# BEACON FEN ENERGY PARK

Statement of Common Ground Between the Applicant and the Forestry Commission

Document Reference: 8.14

October 2025

Figure 4.3. (Ref. *Tree Roots in the Built Environment* (Department for Communities and Local Government – The Stationery Office, 2006)).

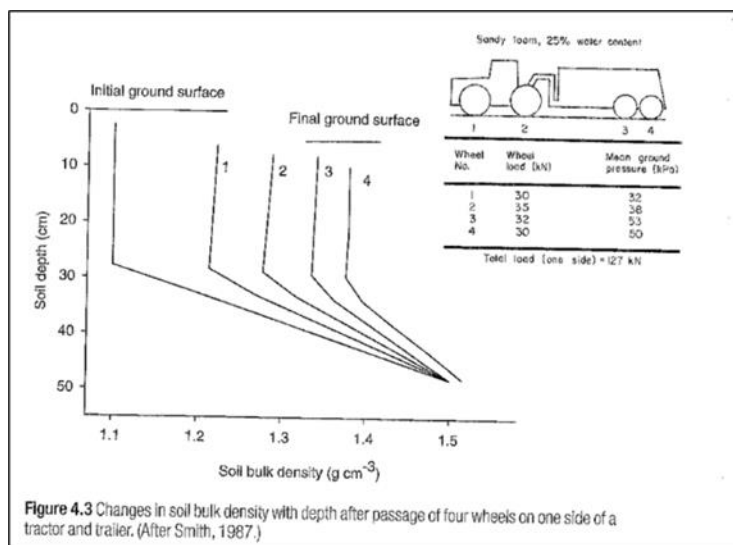
MATTER	COMMENTARY
Construction within veteran trees RPAs, leading to habitat deterioration.	<p>The Forestry Commission submitted a relevant representation consultation response in July 2025, raising concerns that construction is planned within the RPAs of several veteran trees. The draft Statement of Common Ground sent to the Forestry Commission included this Relevant Representation matter within Table 4.1 as a matter not yet agreed during the Pre-Examination stage. The details included in the commentary in Table 4.1 for the client are reproduced below:</p> <p><i>'Two veteran trees were identified in <b>Appendix 6.6 Arboricultural Impact Assessment (Document Ref: 6.3, ES Vol. 2, 6.3.18) (APP-088)</b> as being potentially impacted by the Proposed Development works.</i></p> <p><i>The first veteran tree that was identified as being potentially impacted is tree T95, which is within the Solar Array Area. The potential impact identified was the proposed installation of site fencing within T95's veteran buffer zone (note, not within the tree's BS 5837:2012 derived RPA). It is stated in Appendix 6.6 Arboricultural Impact Assessment (Document Ref: 6.3, ES Vol. 2, 6.3.18) (APP-088) that "The Site fencing shall be located outside of the veteran tree buffer zones of the veteran trees as detailed on the Tree Protection Plan Sheets 1-12 (Drawing ST19595-106-1) at the detailed design stage, which are to be secured post consent by the requirement to prepare a detailed CEMP". Therefore, there will be no deterioration of the veteran tree T95 due to the Proposed Development, as the Site fencing is to be moved out of this tree's Root Protection Areas (RPA) and veteran buffer zone.</i></p> <p><i>The second veteran tree identified in Appendix 6.6 Arboricultural Impact Assessment (Document Ref: 6.3, ES Vol. 2, 6.3.18) (APP-088) as being potentially impacted by the Proposed Development is tree T1124, which is within the proposed Cable Route Corridor. An access route for cable installation works traffic is within this tree's veteran buffer zone and BS 5837 derived RPA. This access route will utilise a well-established existing farm track. This track has an aggregate wearing course that is already compacted from usage to date. As an</i></p>

*existing farm track, the soil underlying this track will have become compacted over time by frequent use by farm vehicles / machinery and, thus, the soil underneath the track is highly unlikely to be suitable for tree root growth due to its already compacted nature. The Department for Communities and Local Government publication 'Tree Roots in the Built Environment (The Stationary Office, 2006)' provides guidance on soil compaction and tree root growth and states that "Pedestrian traffic and vehicle movement cause soil compaction. It is very important to realise that a major contribution to soil compaction occurs in the first pass of vehicles over the ground. Fig. 4.3 shows the increase in soil bulk density in an agricultural soil with a single pass of a tractor and trailer and that a major fraction of the compaction occurs when only two wheels have passed over the ground. The direct impacts of compaction are a loss of pore space and an increase in bulk density. Growth of roots is restricted in compacted soils. Destruction of macropores reduces the number of pathways for root proliferation and increased soil strength causes mechanical impedance for root elongation. Roots are unable to enter pores narrower in diameter than the root cap, unless they can exert sufficient pressure to displace soil particles and widen pore openings. In compacted soil, the pressure required to displace particles is higher than in more loosely packed soil because of increased mechanical strength when particles are forced apart.... Roots are unable to exploit soils which have a bulk density of '1.8 g cm<sup>-3</sup> and above'. The track is a well-established track with a compacted aggregate wearing course and, thus, the soil underlying the track will likely already be compacted to a level that makes it non-conducive for root growth due to previous compaction damage. This already compacted soil is very unlikely to be able to become 'even more' compacted due to use by traffic using it for the cable installation works. As such, use of the track for the cable installation traffic will not be detrimental to the root system of the veteran tree T1124 and will not lead to a deterioration of the physiological functioning of the tree or the veteran habitat that the tree provides.*

The remainder of tree T1124's veteran buffer zone and RPA will be fenced off, during usage of the track as part of the Proposed Development, thereby protecting the unsurfaced parts of the buffer zone and RPA from traffic associated with the Proposed Development. Appendix 6.6 Arboricultural Impact Assessment (Document Ref: 6.3, ES Vol. 2, 6.3.18) (APP-088) states that "If the track is to be upgraded or refurbished, these works shall be assessed by the Project Arboriculturist and appropriate mitigation measures will be specified and complied with". Proposed tree protection measures, including for veteran trees are detailed in Appendix 6.6 Arboricultural Impact Assessment (Document Ref: 6.3, ES Vol. 2, 6.3.18) (APP-088) for the Solar Array Area and Bespoke Access Corridor. The protection measures for the Cable Route Corridor are to be finalised at the detailed design stage in the Arboricultural Method Statement (AMS). Appendix 2.4 Outline Construction Environmental Plan (OCEMP) (Document Ref: 6.3, ES Vol. 2, 6.3.7) (APP-077) includes (at paragraph 6.14) the provision for an AMS and Tree Protection Plans (TPPs) to be prepared at the detailed design stage.
